# Access Compliance Report

## Public Rights-of-Way

### (Curb Ramps)

Intersection ID: 50634	Main Street: BLUE_JASPER_RD	Cross Street: CORAL_ROSE_RD	Location: SW
ADA ID: 02C05D58B258	Ramp Type: Perp	Initial Pass/Fail: Fail	Overall Compliance: No
Severity Score: 10			
Codes/Mitigation Info/Possible Solution		Field Measurements/Component Compliance

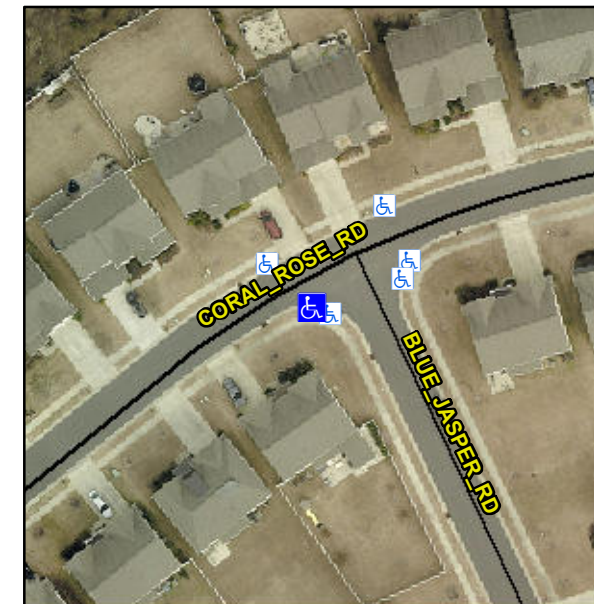
**Not Found, R304.5.1, R304.5.3**

Compliance	Description	Data	Compliance	Description	Data
N/A	Ramp Length (in)	46.5	Yes	Ramp Slope (%)	7.9
No	Ramp Width (in)	47.0	No	Ramp XSlope (%)	3.5
N/A	Flare Type LT	N/A	N/A	Flare Type RT	N/A
N/A	Flare Slope LT (%)	N/A	N/A	Flare Slope RT (%)	N/A
N/A	Flare Traversable LT?	N/A	N/A	Flare Traversable RT?	N/A
N/A	Landing Length (in)	N/A	N/A	DWS Provided?	N/A
N/A	Landing Width (in)	N/A	N/A	DWS Contrast?	N/A
N/A	Landing Slope (%)	N/A	N/A	DWS Length (in)	N/A
N/A	Landing X Slope (%)	N/A	N/A	DWS Full Width?	N/A
N/A	Landing Curb? (Y/N)	N/A	N/A	DWS Offset (in)	N/A
N/A	Shared Landing?	N/A			
N/A	Gutter Ponding?	N/A	N/A	Gutter Slope (%)	N/A
N/A	Gutter Lip Ht (in)	N/A	N/A	Gutter X Slope (%)	N/A
N/A	Painted X Walk1?	No	N/A	Painted X Walk2?	N/A
	X Walk 1 Direction	To NW		X Walk 2 Direction	N/A
N/A	X Walk 1 Width (in)	N/A	N/A	X Walk 2 Width (in)	N/A
	X Walk 1 Slope (%)	0.3		X Walk 2 Slope (%)	N/A
	X Walk 1 X Slope (%)	2.2		X Walk 2 X Slope (%)	N/A

**Remove & Replace Entire Ramp.**
